Model: Di-C1/C1L	Date: 09-Dec-08	No.: RD038001d
------------------	-----------------	----------------

Subject: Firmware Release Note: Engine		Prepared by: M. Saiki	
From: 2nd Overseas Tech Support Sec., 2nd PQM Dept.			
Classification:	<input type="checkbox"/> Troubleshooting	<input type="checkbox"/> Part information	<input type="checkbox"/> Action required
	<input type="checkbox"/> Mechanical	<input type="checkbox"/> Electrical	<input type="checkbox"/> Service manual revision
	<input type="checkbox"/> Paper path	<input type="checkbox"/> Transmit/receive	<input type="checkbox"/> Retrofit information
	<input checked="" type="checkbox"/> Other (      )

This RTB has been issued to announce the firmware release information for the **Engine of the Model Di-C1 and Di-C1L**.

**NG** (the pressure roller stay has been bent): Notice the gap between the metal plates.

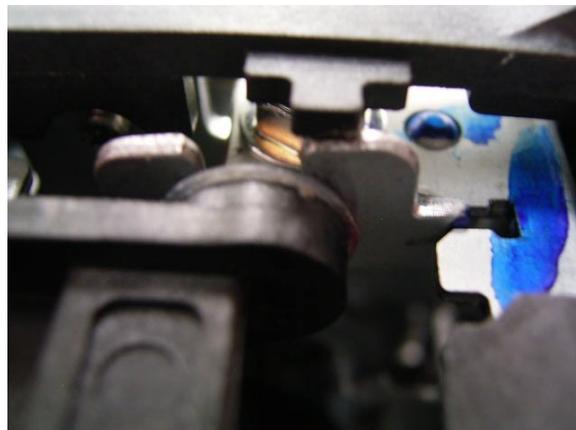
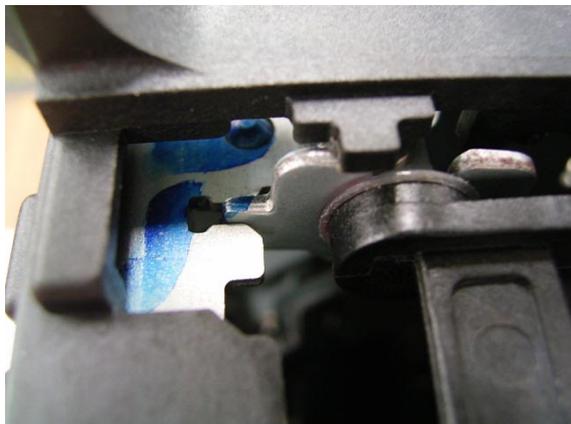
If there is a gap between the metal plates shown in the photo below, this means the pressure roller stay has been bent, so replace the pressure roller stay (P/N D0394183).

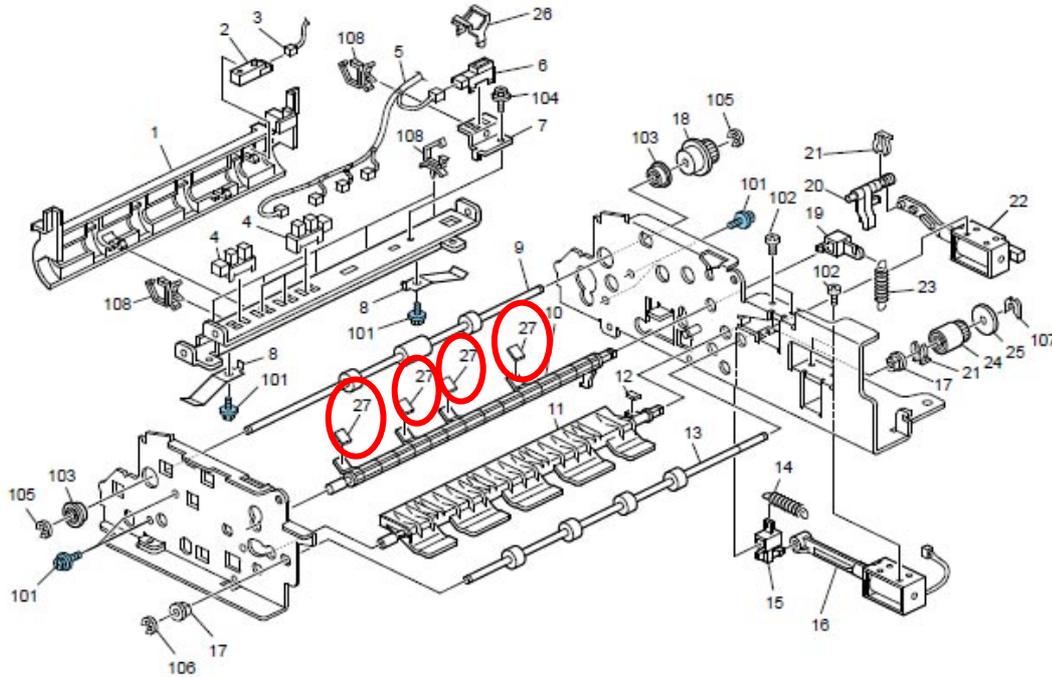
Basically, the original stopper helps keep the original document still when the original is set. The pad was added to prevent a curled original from passing over the stopper, which could cause incorrect paper size detection.

**See the diagram on the next page to confirm the positions of the pads. The pads are numbered 27 and encircled in red.**

If the symptom is reported, remove the pads from the stopper. This is a temporary countermeasure.

**Fax Option Type C2550/ C2530  
Installation Procedure (pg. 6)**

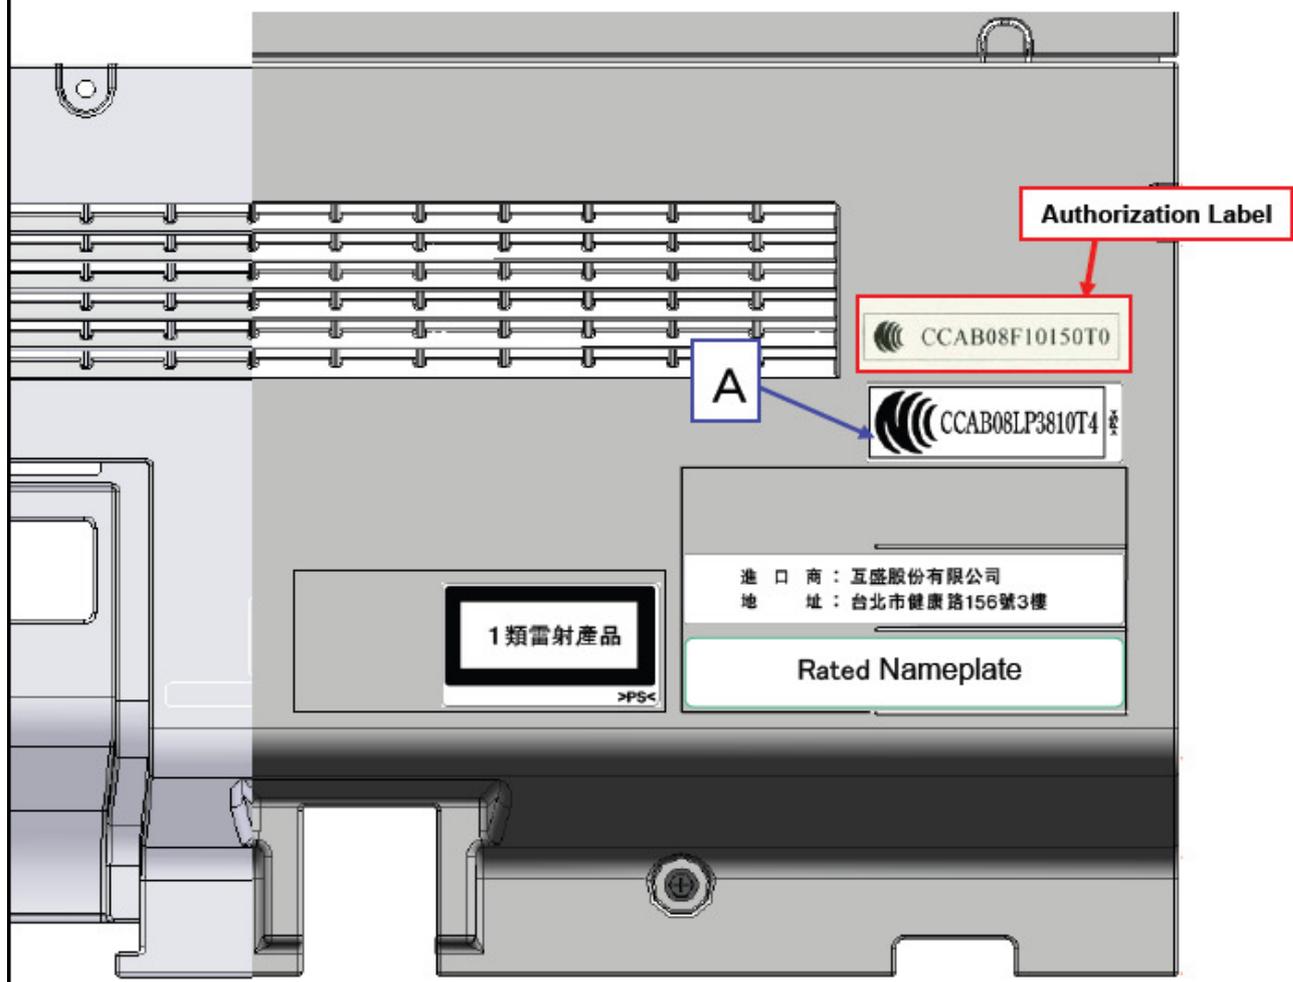
**Replace** Step 2 on pg. 6 of the D432/ D433 Service Manual with the following:

2. For China and Taiwan models, attach the authorization label above the RFID label ([A]).  
**Important:** Make sure the decal does not overlap with any other decal. **See the diagram below.**

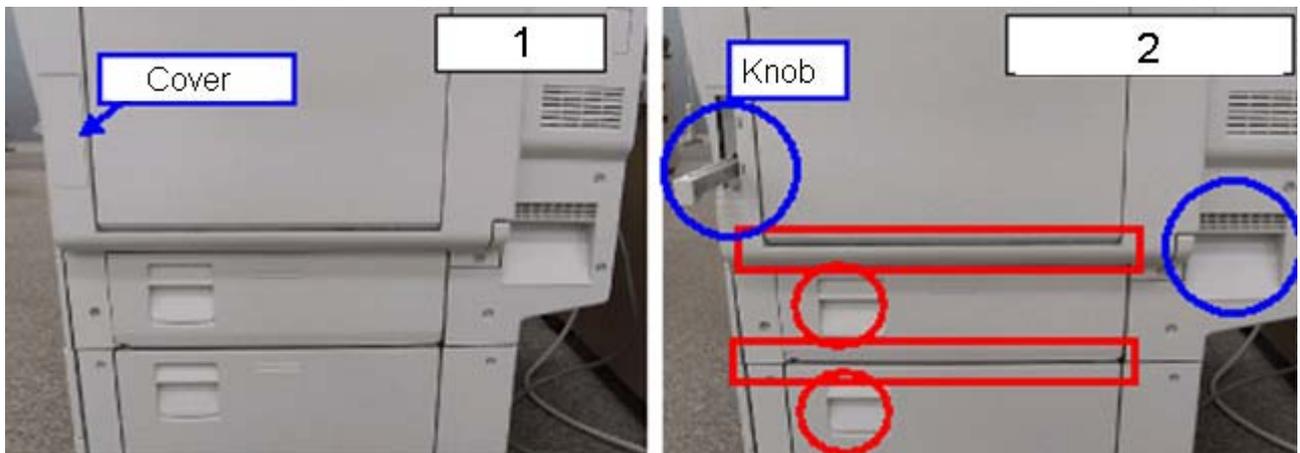
Jam code 011, 012, 051, or 052 (transport sensor jams) occurs.

When the machine is moved, it is held by one of the edges circled in red in the photos below. This deforms the bracket for the vertical transport cover.

2. If the symptom is reported, and the brackets for the vertical transport covers are damaged or deformed, replace both brackets (Front: P/N D0392938, Rear: P/N D0392939).

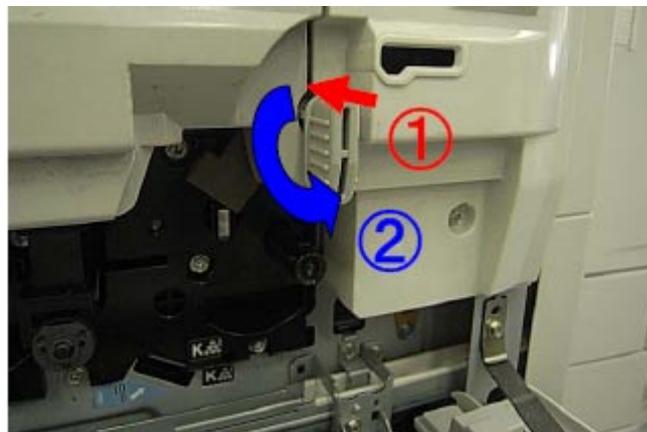
**Change:** The shape of the knob was changed.

**Reason:** To further strengthen the knob.

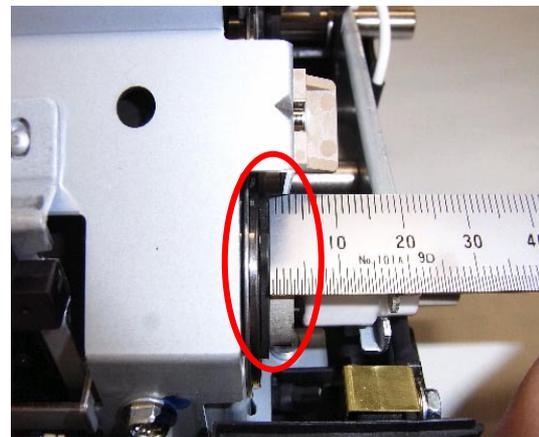
1. **Do not press the stay** when attaching the two springs.

2. Make sure there is a clearance of **2mm +/- 0.3** between the retaining rings on both sides of the hot roller and the edge of the upper stay.

**P/N D0394952    BRACKET:SENSOR:FUSING EXIT**

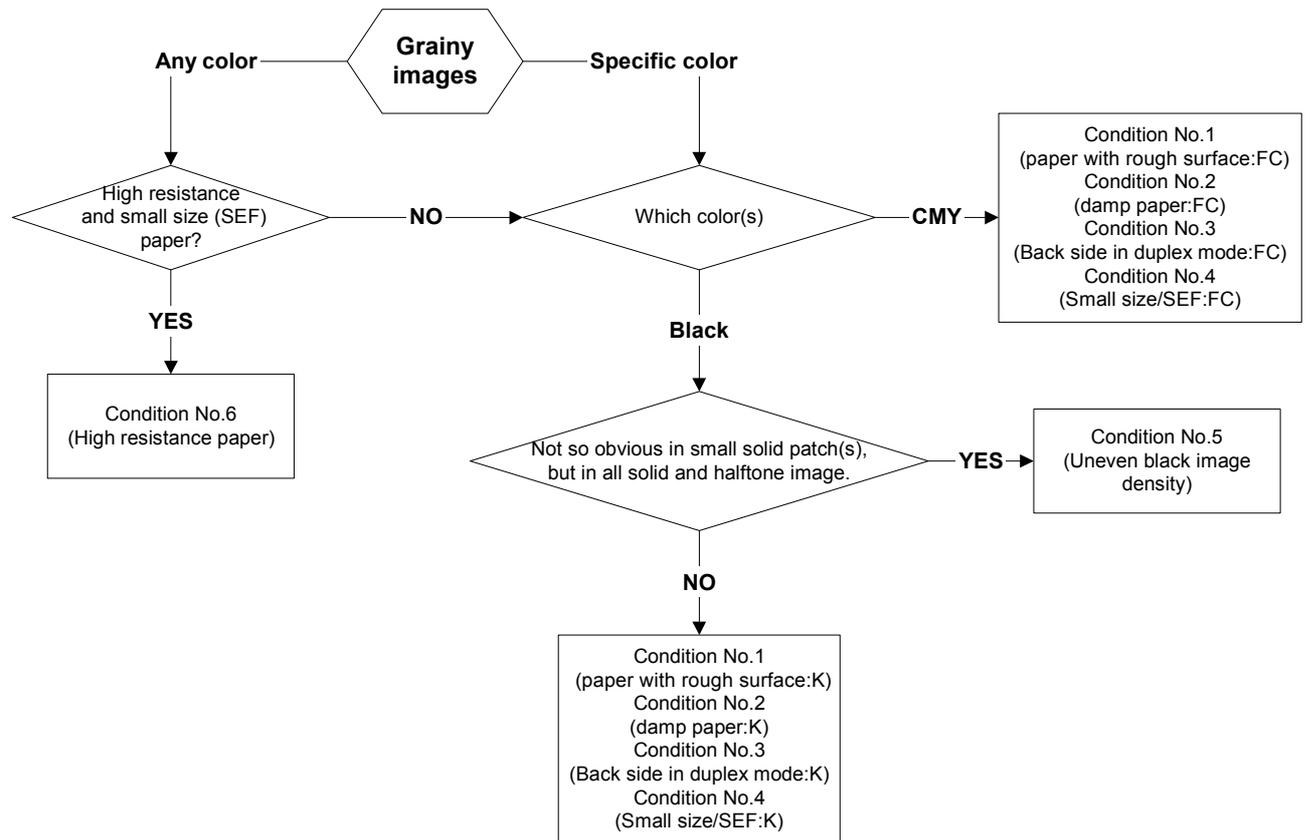
As the temperature inside the machine rises, the fusing exit sensor (reflective photosensor) can sometimes detect the upper section of the guide plate as a sheet of paper. As a result, the machine triggers Jam code 059.

If this symptom is reported, replace the sensor bracket with the following:

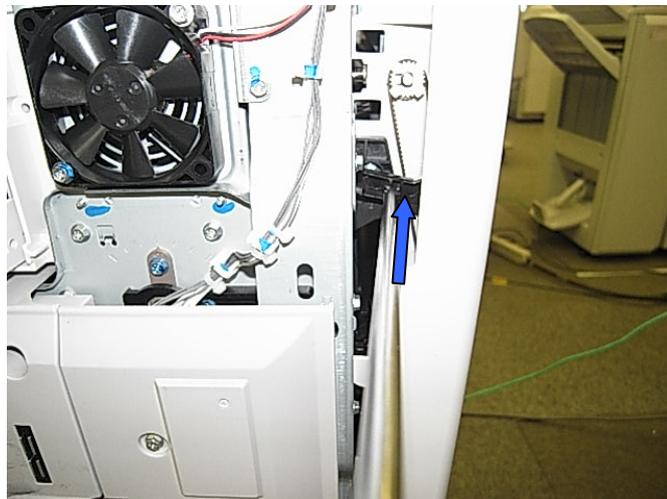
The shape of the front pressure lever was changed to minimize the lever's side-to-side play, and to further ensure that the front pressure release arm cannot contact the lever when the cover is closed.

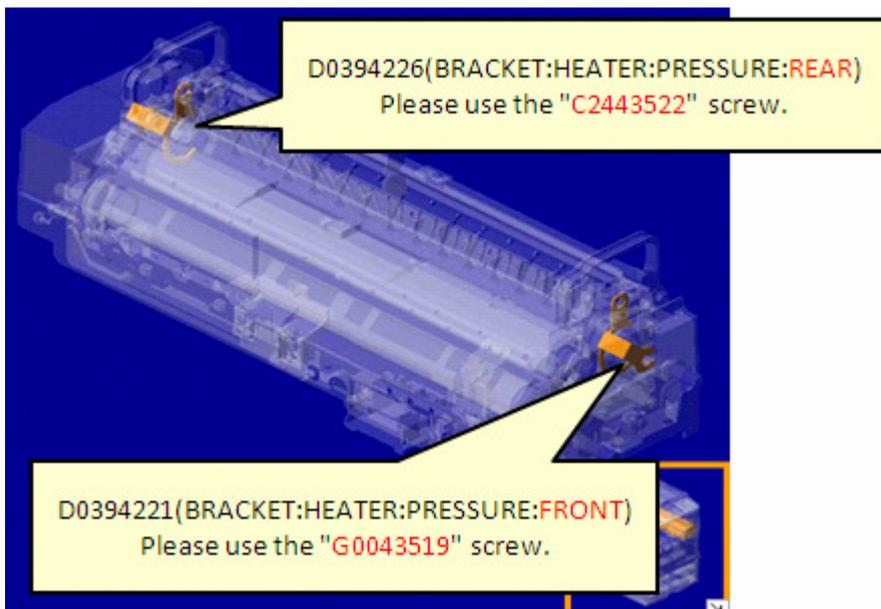
**Change:**

- The shape of the rear bracket for the pressure heater was changed.
- The screw for the bracket was changed to a different type.
